## **Circuit Change (Revised)**

**NAD Electronics International**

**02/13/03**

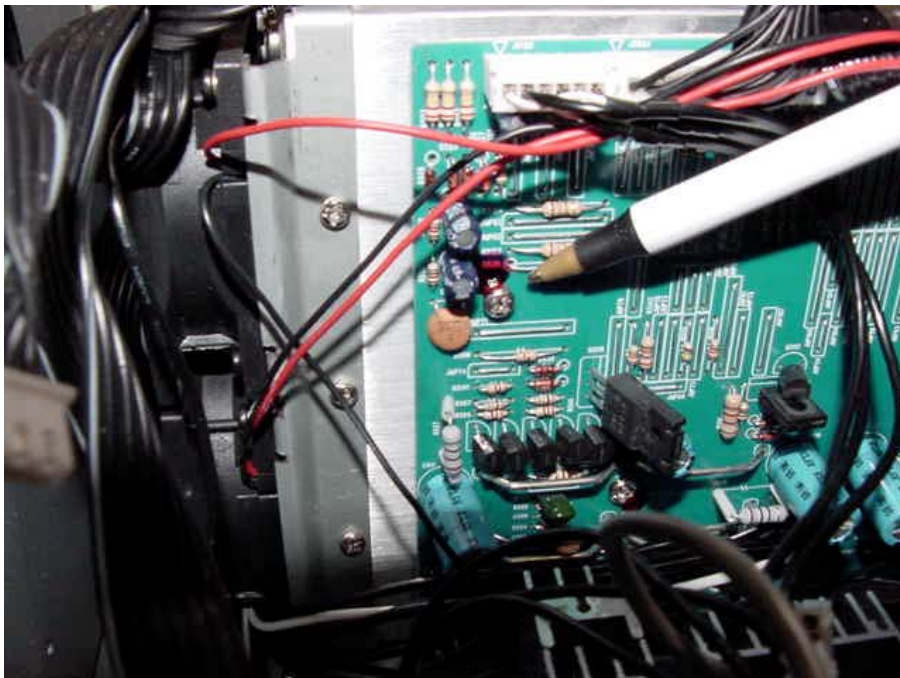
**PROBLEM:** *You may have the complaint, receiver turns on and the front panel display shows the message “OVERHEAT”.*

**CAUSE:** *A screw on the power amplifier circuit board is loose causing a poor ground and triggering a false “overheat” condition.*

*Looking from the front of the unit, locate and tighten the screw on the amplifier board which is on the right hand side of the power amp module.*

***PART B: Add a ground wire connecting the thermal switch (ground pin), and the mounting pin of S351 in TRIGGER PCB.***
